#### RE: COA-23-003 (ZON-23-020) 139 N County Road (Paramount Theatre) Responses to Comments Palm Beach, Florida KH #241020000

We are in receipt of comments from the Corradino Group, Inc. dated May 9, 2024, regarding the traffic analysis for the 139 N County Road (Paramount Theatre) site in the Town of Palm Beach. That traffic study has been updated to address these comments and to reflect further refinements made to the site plan. Below are our responses to each of the comments that were denoted as "still pending"; comments noted as "Addressed" have been eliminated for brevity.

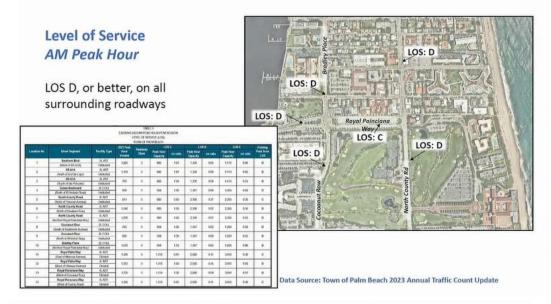
8. Please include on-site field observations of the surrounding road network during peak traffic periods (AM, Midday, Midafternoon and PM) to note any traffic operational deficiencies. The recent conversion of Sunset Avenue from a two-way roadway facility to a one-way eastbound roadway facility has created surrounding traffic circulation issues as noted by the Town of Palm Beach Police Department and depicted in a recent aerial drone video. The field observations should include confirmation of the 95th percentile vehicle queuing at the key turn lanes at the subject intersections.

TCG 05/09/24 Response: This item is still pending. Please provide this additional information.

**Kimley Horn and Associates, Inc.'s 04/10/24 Response:** Aerial photographs of observations were conducted during peak hours at the adjacent intersections on North County Road. Primarily, queue spillback between adjacent intersections was observed to occur during the weekday mid-day (e.g., around noon) and mid-afternoon (e.g., around 3 PM) time periods. It has been noted that the proposed redevelopment plan will result in reduced potential traffic during those time periods in comparison to full occupancy of the currently existing uses on site. Photographs will be provided under separate cover.

**RESPONSE**: Aerial drone photography for the periods noted previously have been included in the supplemental comment response document, for reference.
